# Beckfoot Heaton School - Accessibility Action Plan.

Updated: 10/01/2025

15.3

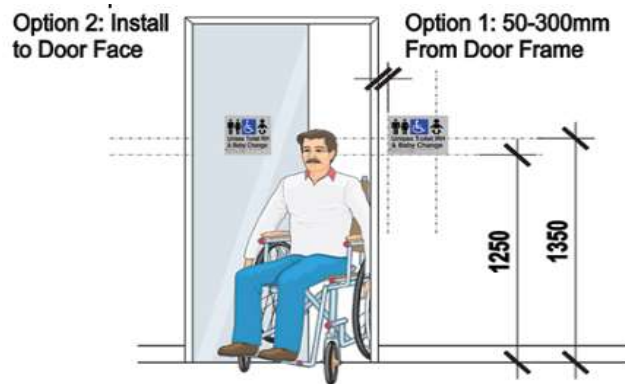
Some WC facilities were suitably signed with pictorial information.

The signage on facility 42 was slightly damaged.

The Hygiene Room 270 was not suitably signed for its purpose.

The WC facility 171 in years 5 and 6 was not suitably signposted.

The appropriate toilet signage should be provided. As well as signage on the toilet doors, there should also be signs indicating where the accessible WCs are located.

BS8300 states - Information and direction signs should be provided at each point where they are required, e.g. at junctions of circulation routes, at key locations such as doorways and reception points, at facilities such as telephones and toilets, and in rooms, spaces and counters. The colour, design and typeface of signs should be consistent throughout a building.

All accessible WC door signage should ideally be accessible to all disabled people with Braille and embossed lettering preferred.

Raised lettering / Braille Toilet signs added to 3 doors 263,270 & 171

a) Elevation (for clarity excluding fixed grab rails on rear wall with shower fitting)

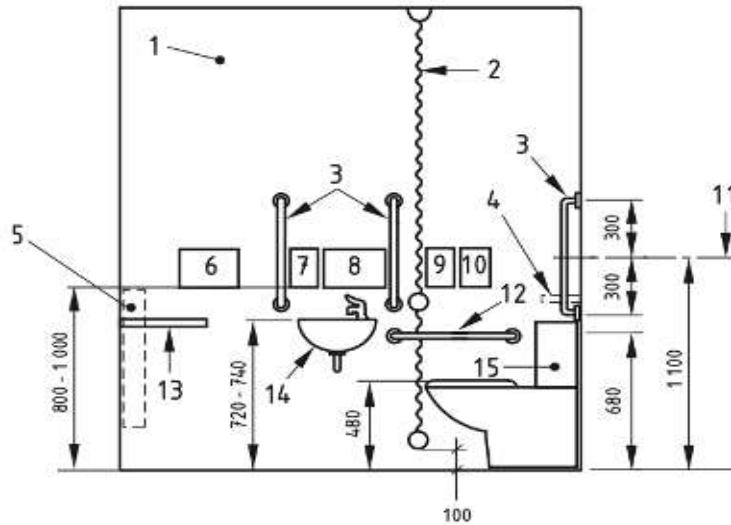
12.8	<p>A level access shower was identified in Hygiene Room 270. This facility did not feature a drop-down chair or contrasted grab rails. A hoist system was also provided to this facility.</p> <p>The student coat storing areas did not feature areas with lowered coat hooks, which could assist people who are short in stature.</p>	<p>A padded tip-up seat should be securely fixed to the wall and drop-down support rails and grab rails for a self-contained shower/ changing area should be located as shown in Figure 37.</p> <p>It may be beneficial to provide clothes hooks at two heights, one level at 1050mm and the other at 1400mm above the floor.</p>	M
